Access Compliance Report Public Rights-of-Way (Curb Ramps)

Main Street: GIGI_DR Cross Street: SMOKE_TREE_LN Location: SE

ADA ID: RPRK211013150810 Ramp Type: Type 1 - Perpendicular Diagonal Initial Pass/Fail: Pass Overall Compliance: No Severity Score: 20

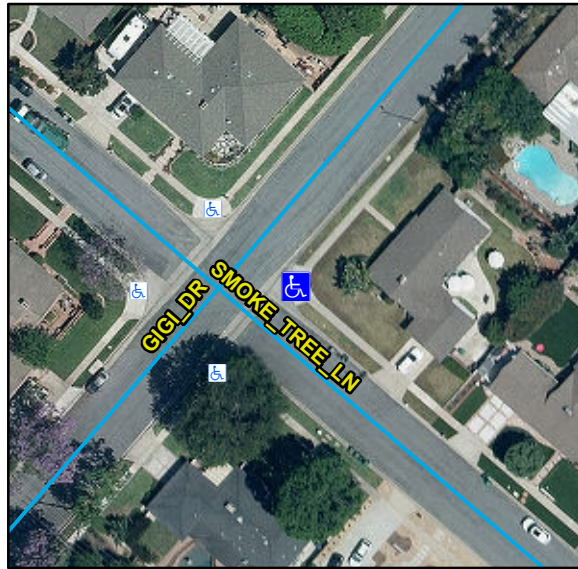
Compliance	Description	Data	Compliance	Description	Data
N/A	Ramp Length (in)	110	N/A	Flare Type LT	
Yes	Ramp Width (in)	48			Sloped
Yes	Ramp Run Slope (%)	3.8	N/A	Flare Slope LT (%)	7.7
Yes	Ramp Cross Slope (%)	0.4	N/A	Flare Traversable LT	No
N/A	Landing Present	No	N/A	Flare Type RT	
N/A	Landing Length (in)	N/A			Sloped
No	Landing Width (in)	N/A	N/A	Flare Slope RT (%)	3.3
No	Landing Run Slope (%)	N/A	N/A	Flare Traversable RT	No
No	Landing Cross Slope (%)	N/A	No	DWS Provided	No
N/A	Landing Movement Obstructed?	Yes	N/A	DWS Contrast	N/A
	Landing Movement Type	Curb	N/A	DWS Length (in)	N/A
N/A	Landing Shared	N/A	N/A	DWS Full Width	N/A
N/A	Clear Space	Yes	N/A	DWS Offset Left (in)	N/A
N/A	Clear Space To Crosswalk (in)	48	N/A	DWS Offset Right (in)	N/A
N/A	Marked Crosswalk 1	No	N/A	Marked Crosswalk 2	No
	Crossing 1 Direction	NW		Crossing 2 Direction	SW
	Marked Crosswalk 1 Width (in)	N/A		Marked Crosswalk 2 Width (in)	N/A

N/A	Ramp Inside Crosswalk 1	N/A	Yes	Ramp Inside Crosswalk 2	N/A
	Crossing 1 Slope (%)	3.1		Crossing 2 Slope (%)	0.1
	Crossing 1 Cross Slope (%)	2.8		Crossing 2 Cross Slope (%)	0.9
Yes	Gutter Ponding	No	Yes	Curb Slope	1.5
Yes	Gutter Lip Height (in)	0		Road Run Slope (%)	2.1
Yes	Gutter Run Slope (%)	1.4		Road Cross Slope (%)	1.6
Yes	Gutter Cross Slope (%)	1.6			
Yes	Overall Surface Condition: Acceptable		Yes	Perp Joint Present	Yes
	Cross Gutter Present?	Yes		Spandrel Present?	Yes
	Replace Cross Gutter?	No		Replace Spandrel?	No

Remove & Replace Curb Ramp With Two New Directional Ramps or Equivalent.
